HOPE CREEK GENERATING STATION  
DOCKET NO. 50-354  
FSAR COMMITMENT STATUS THROUGH AUGUST 1984

ATTACHMENT I  
HOPE CREEK GENERATING STATION  
FSAR COMMITMENT STATUS THROUGH AUGUST 1984

QUESTION 220.21 (SECTION 3.7.2)

FIGURE 210.21-22  
 RESPONSE SPECTRA COMPARISON,  
 AUXILIARY BUILDING AT ELEV. 54' -0",  
 N-S, OBE, 2% DAMPING

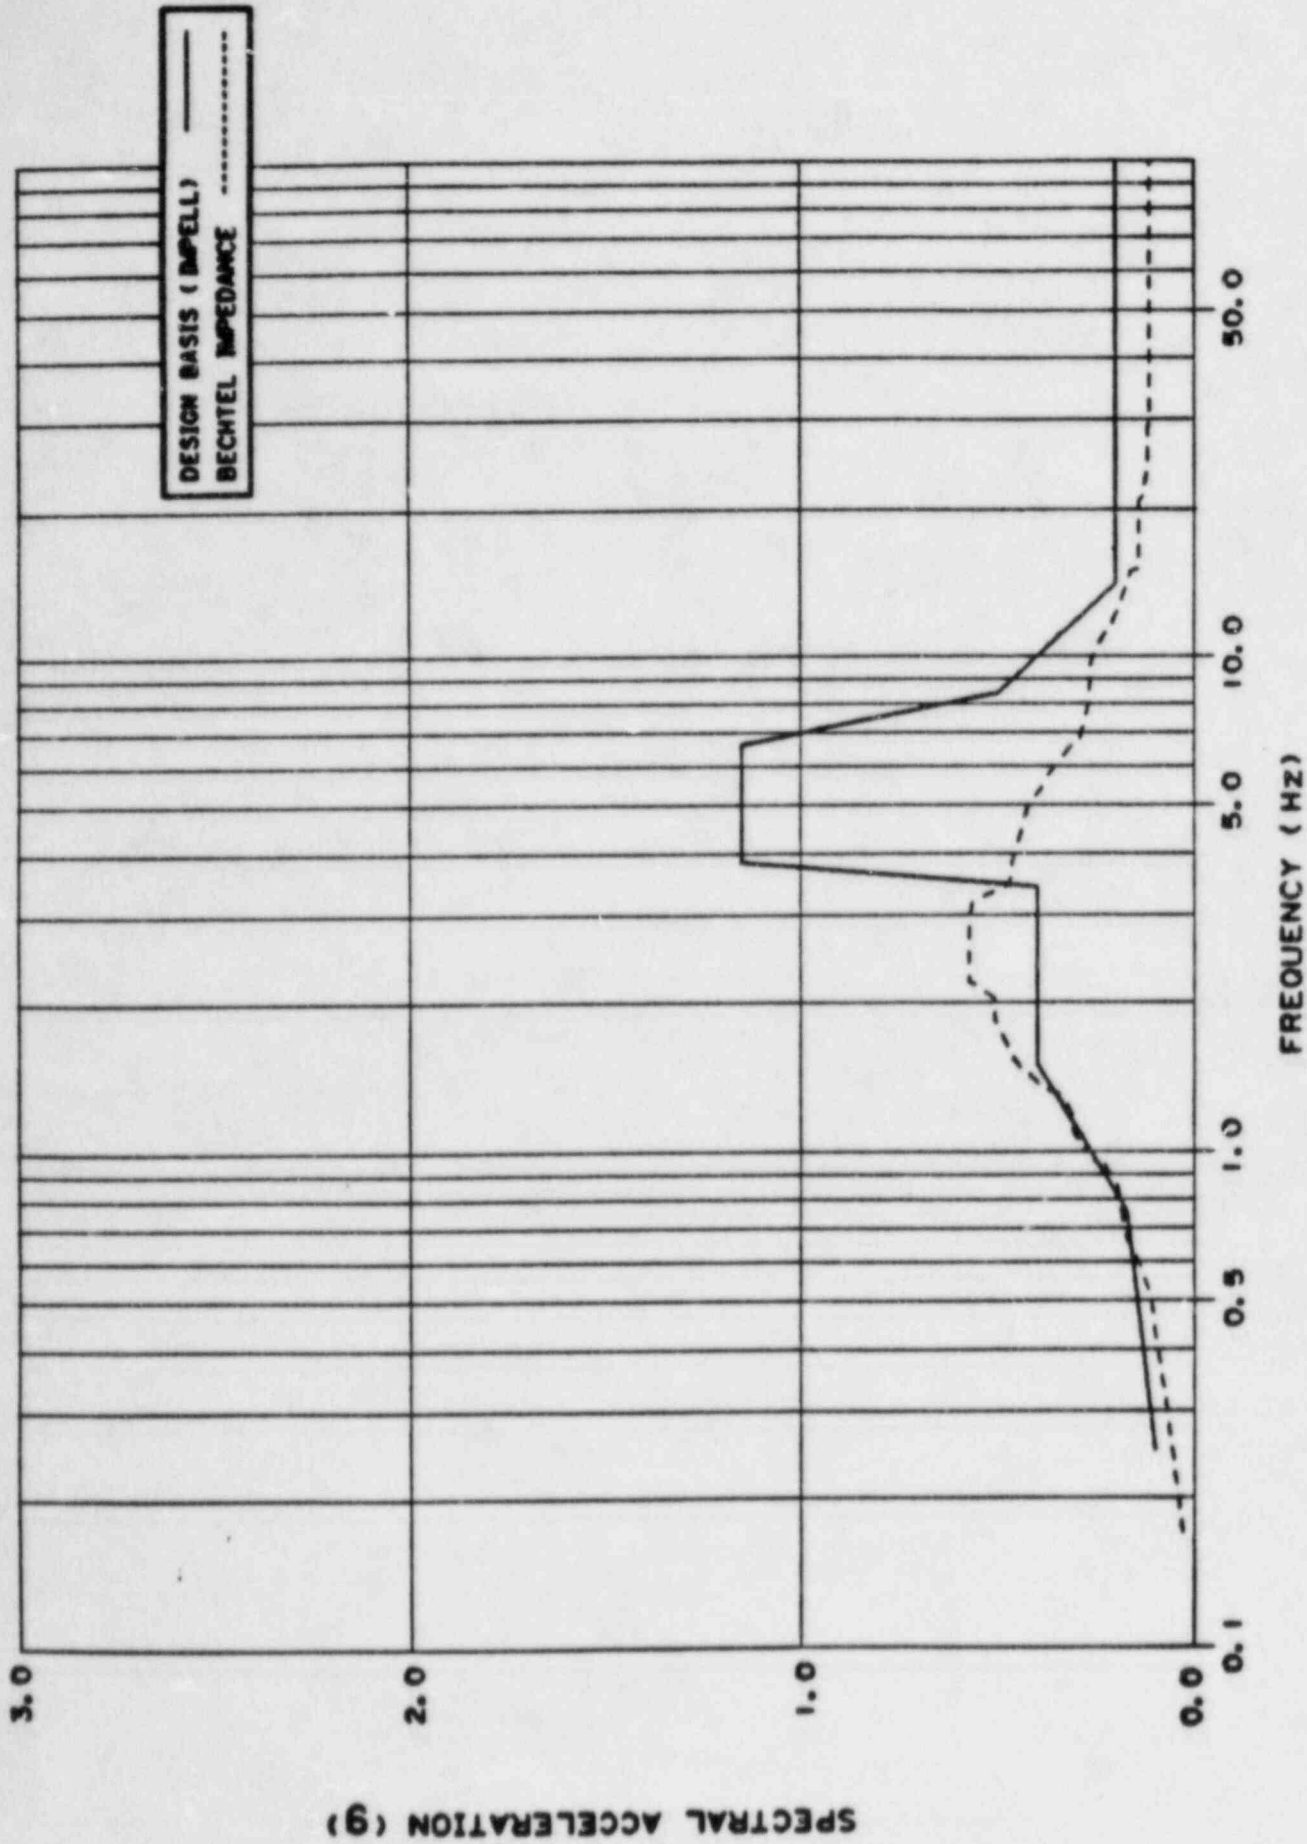
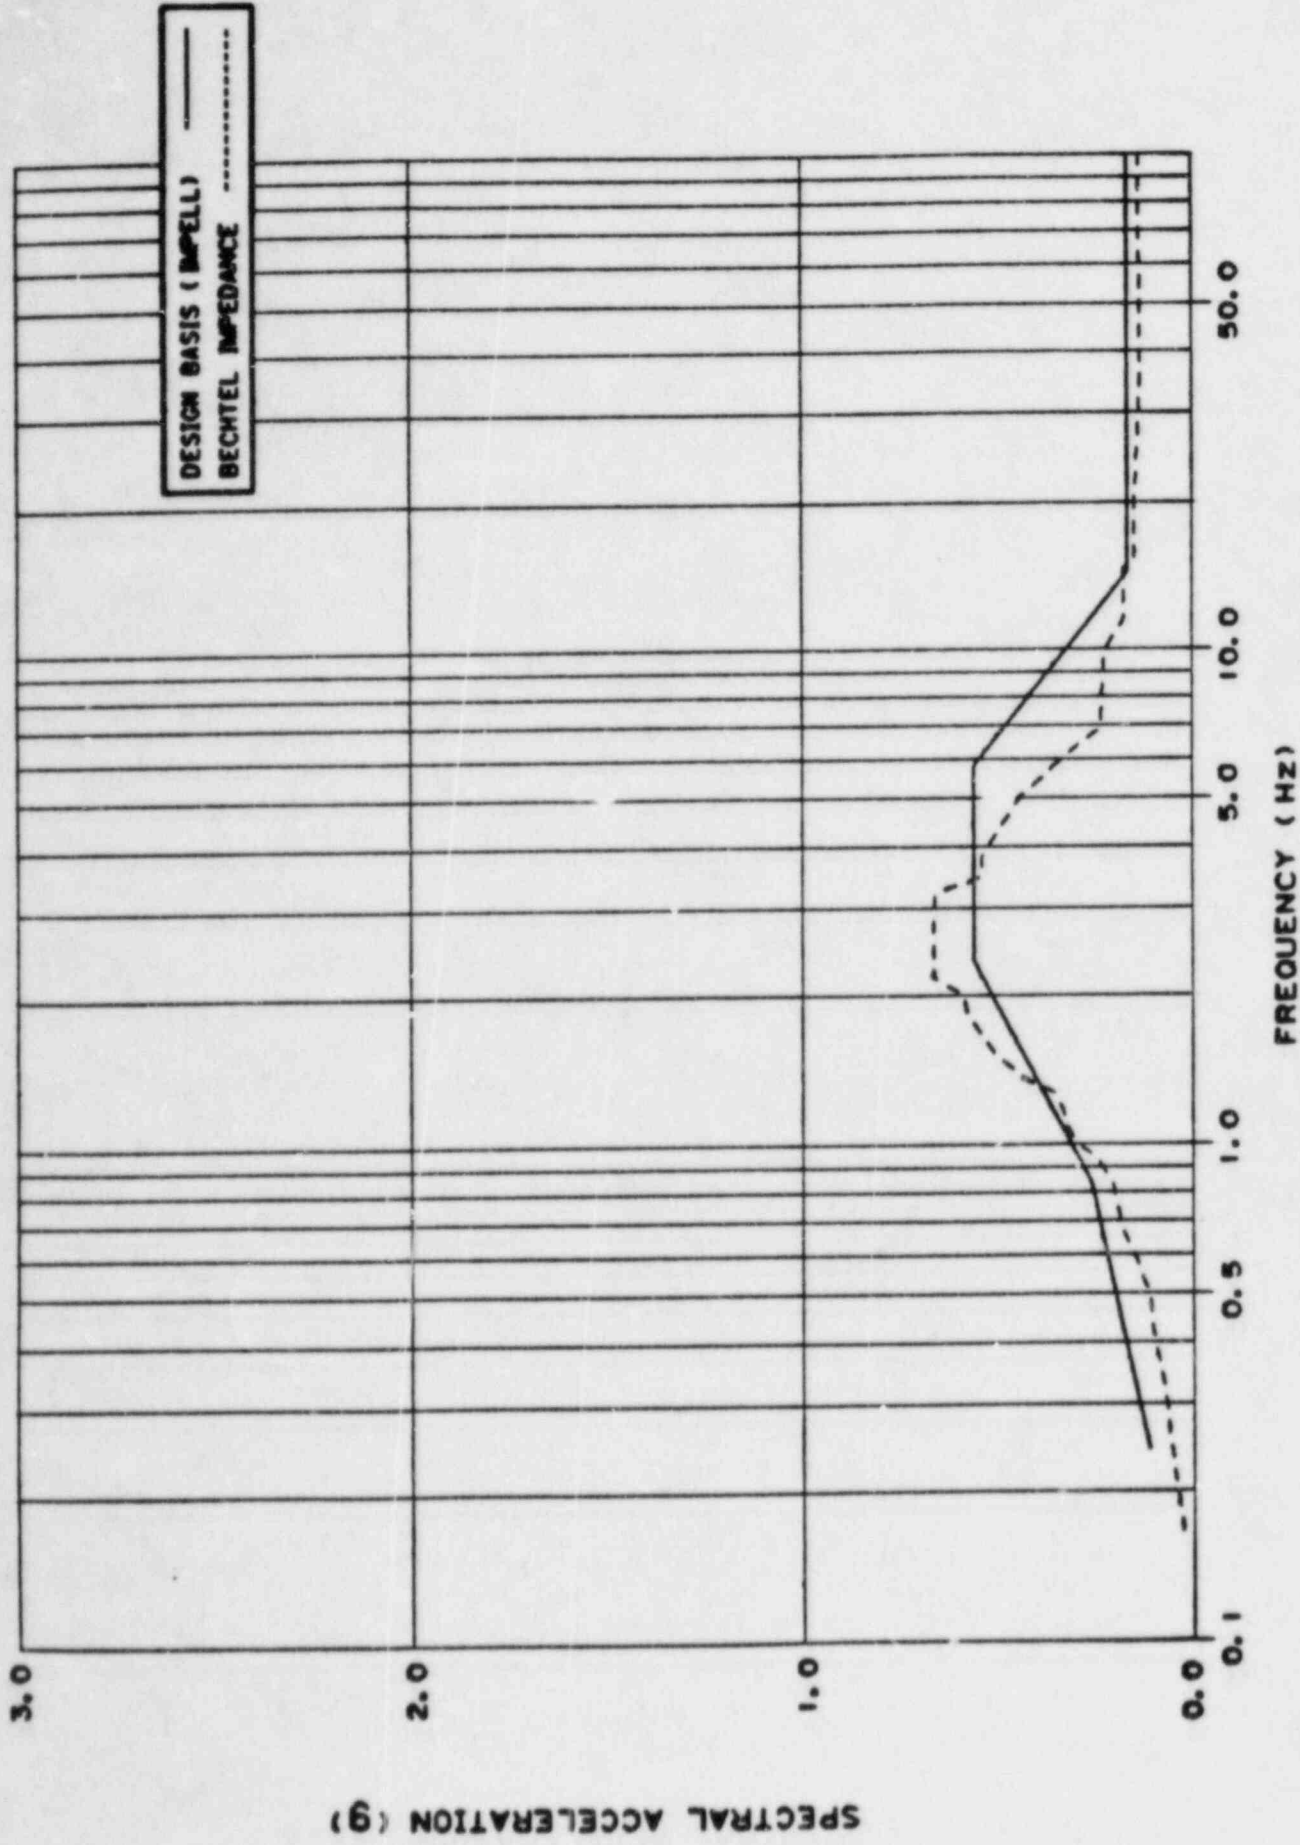
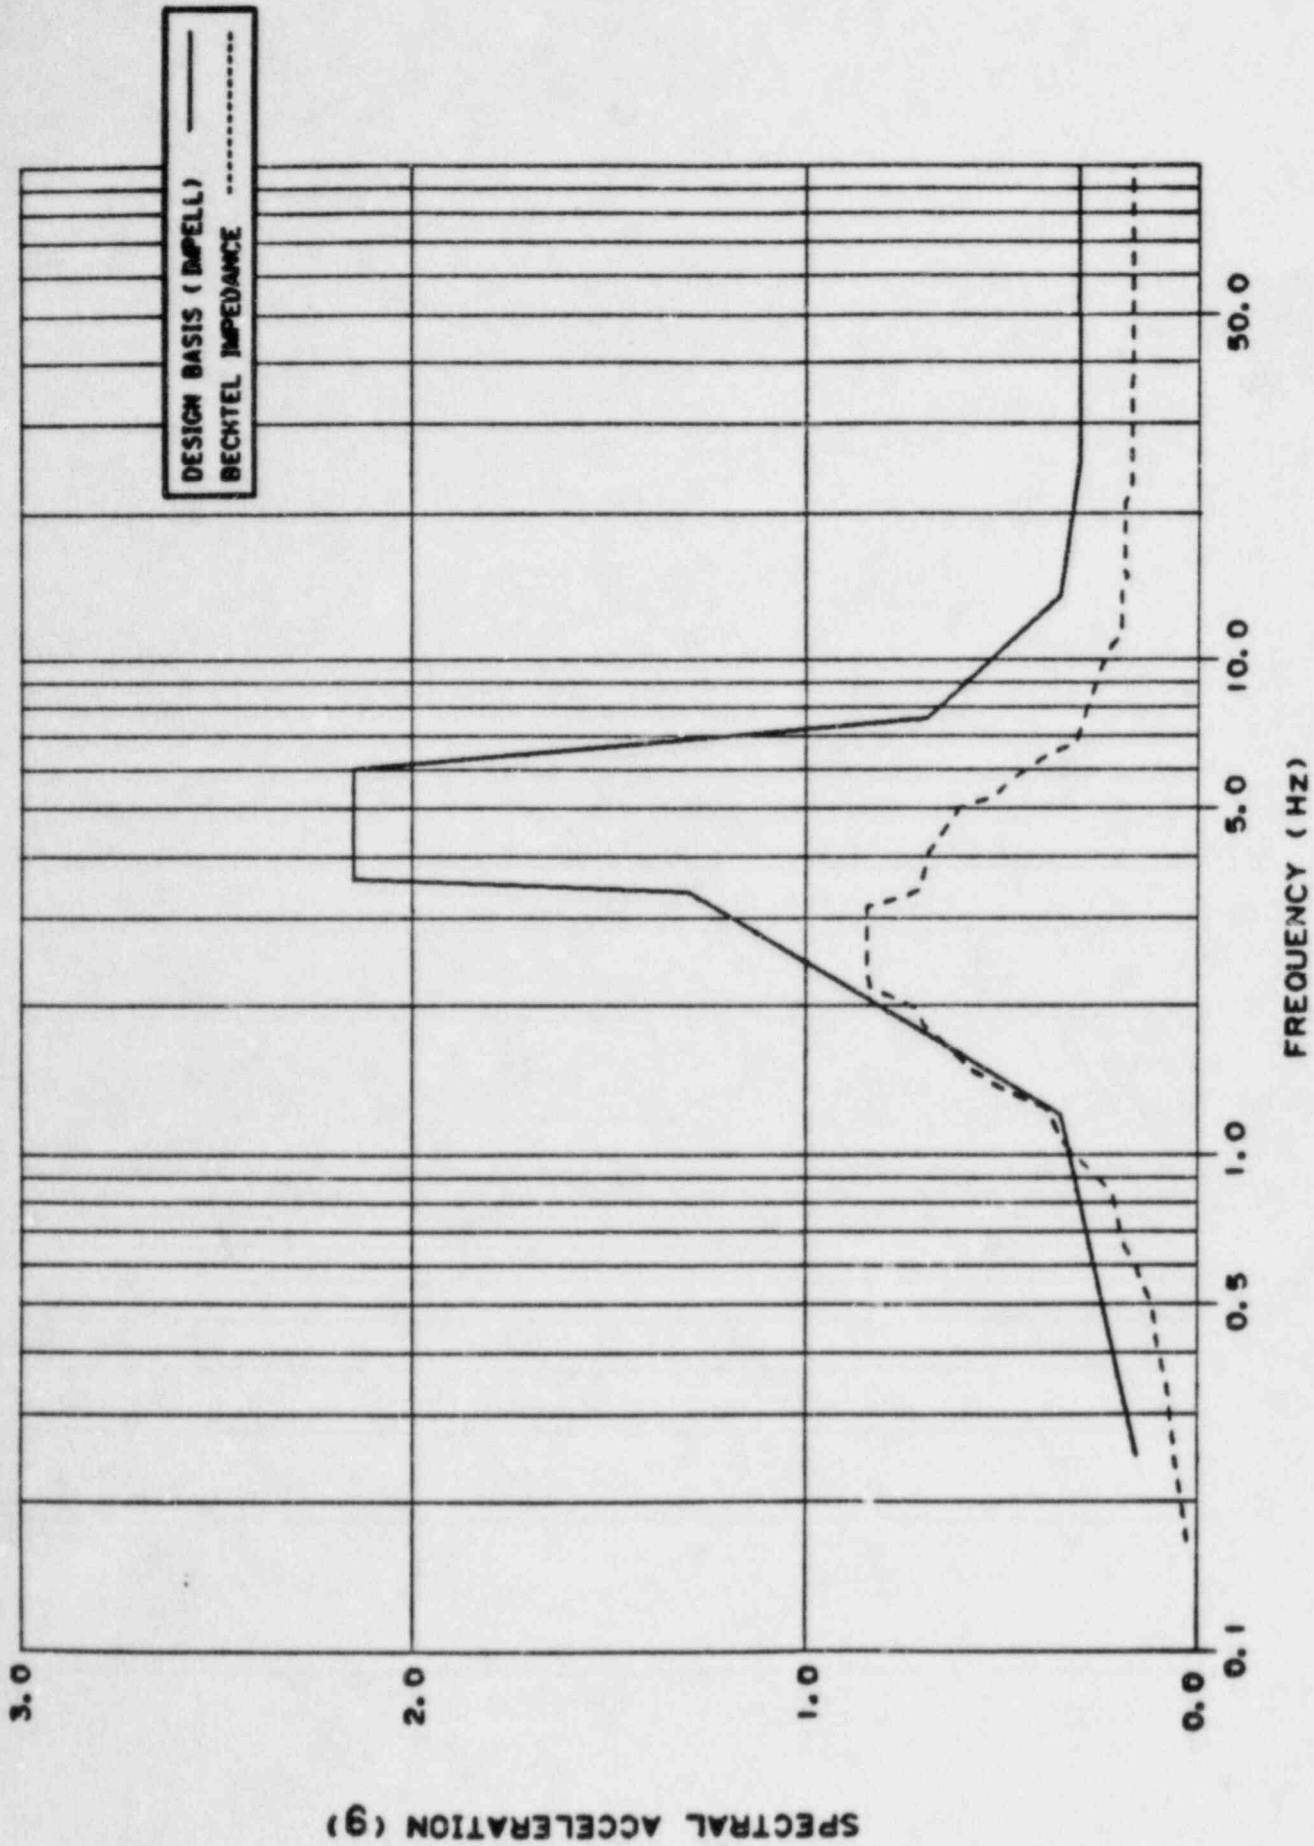
The Hope Creek soil-structure interaction analysis is performed by applying a specified earthquake input motion at the base of the finite-element model. The base level input motion is generated through a deconvolution analysis. The applicable SRP criteria for soil-structure interaction analysis require that both the half-space and finite-element approaches should be considered. (For details refer to SRP 3.7.2-11.4). Public Service should perform necessary analyses to demonstrate conformance to the criteria.

Figures 220.21-1 through 220.21-54 show a comparison of the 2 percent damping response spectra obtained from the design basis finite element and the impedance analyses for the reactor building, auxiliary building and the service water intake structure (SWIS).

¶ For the reactor and auxiliary buildings, the peak spectral accelerations obtained from the impedance analysis are generally lower than those obtained from the design basis analysis. However, the impedance analysis response spectra are not completely enveloped by those obtained from the design basis analysis, especially in the frequency range from 1.0 to 3.5 Hz. Also, there are some local exceedances in the higher frequency range, as shown in Figures 220.21-1 through 220.21-36. ¶ For the SWIS (Figures 220.21-37 through 220.21-54), the impedance analysis response spectra are generally enveloped by those obtained from the design basis analysis at elevation 114.0 feet. For other elevations, the impedance analysis spectral accelerations exceed the design basis spectral accelerations in some frequency ranges. These ranges vary approximately between 1.5 and 10.0 Hz.

forces and moments obtained from the impedance analysis exceeded the design basis values at various locations within these buildings. The auxiliary building seismic shear forces and moments obtained from the impedance analysis are less than the design basis shears and moments.

Since the impedance analysis results are not completely enveloped by the design basis finite element analysis results, sampling studies are conducted to confirm the adequacy of the plant design. These sampling studies include an evaluation of the following items:

In all cases, the items reviewed during these sampling studies can accommodate the loads resulting from the impedance analysis. Therefore, the impedance analysis results have no impact on the plant design.
